SLUP-17
(2016)

CLIENT: TAYLOR/THEUS HOLDINGS
1213 LA SALLE DRIVE
ATLANTA, GEORGIA 30308
PROJECT NO.: 1713 LA SALLE DRIVE
DATE: 10/05/2016
PROJECT NO.: 1713 LA SALLE DRIVE
SOUTH COBB DRIVE AT I-285
REZONING SITE PLAN

ZONING COMMENTS: Staff Member Responsible: Terry Martin, MPA

SHEET NUMBER: C0-20

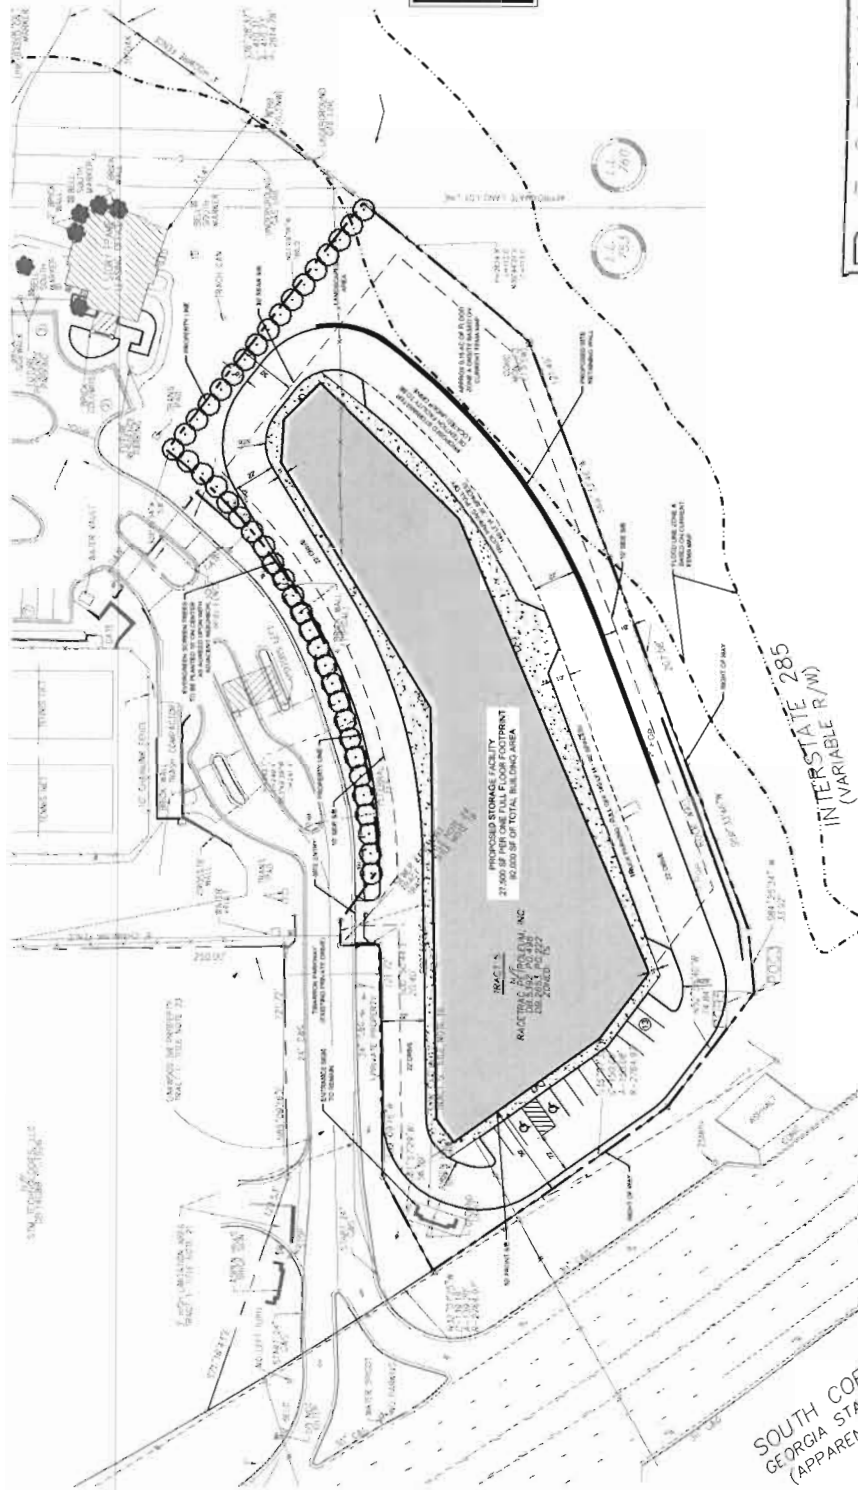
The proposed parking area does not comply with the Cobb County Tree Ordinance. Additional parking lot peninsulas and/or islands may need to be provided so as to meet Tree Ordinance parking lot tree requirements. In addition, there is insufficient separation between the drive aisle and R/W to provide the required 8' landscape enhancement strip along the west property line.

- Provide comprehensive hydrology/stormwater controls to include development of out parcels.
- Submit all proposed site improvements to Plan Review.
- Any **spring activity** uncovered must be addressed by a qualified geotechnical engineer (PE).
- Structural fill _____ must be placed under the direction of a qualified registered Georgia geotechnical engineer (PE).
- Existing facility.
- Project must comply with the Water Quality requirements of the CWA-NPDES-NPS Permit and County Water Quality Ordinance.
- Water Quality/Quantity contributions of the existing lake/pond on site must be continued as baseline conditions into proposed project.
- Calculate and provide % impervious of project site.
- Revisit design; reduce pavement area to reduce runoff and pollution.

- No Stormwater controls shown _____
- Copy of survey is not current – Additional comments may be forthcoming when current site conditions are exposed.
- No site improvements showing on exhibit.

1. This site is located at the northeast corner of South Cobb Drive and I-285. The entire site drains to the northeast into an unnamed tributary to the Chattahoochee River. The southern boundary of the site is impacted by the 100-year floodplain of this stream. Cobb County Stormwater Management has computed 100-year elevations for this stream reach that are more accurate than the effective FEMA FIRM map panels. Based on the County’s GIS topography, it appears that the floodplain is not as extensive as shown on the FIRM map. Field run topography will be required during Plan Review to verify the actual flood boundary. No fill will be allowed within the actual 100-year floodplain. The proposed underground stormwater management facility must be located above the floodplain as well.

1. Site plan received by the Zoning Division on October 6, 2016, with the District Commissioner approving minor modifications;
2. Architectural elevations to be approved by the District Commissioner prior to issuance of building permits;
3. Landscape plan to be reviewed by County Arborist and approved by District Commissioner prior to land disturbance;
4. Water and Sewer Division comments and recommendations;
5. Stormwater Management Division comments and recommendations;
6. Fire Department comments and recommendations; and
7. Department of Transportation comments and recommendations.
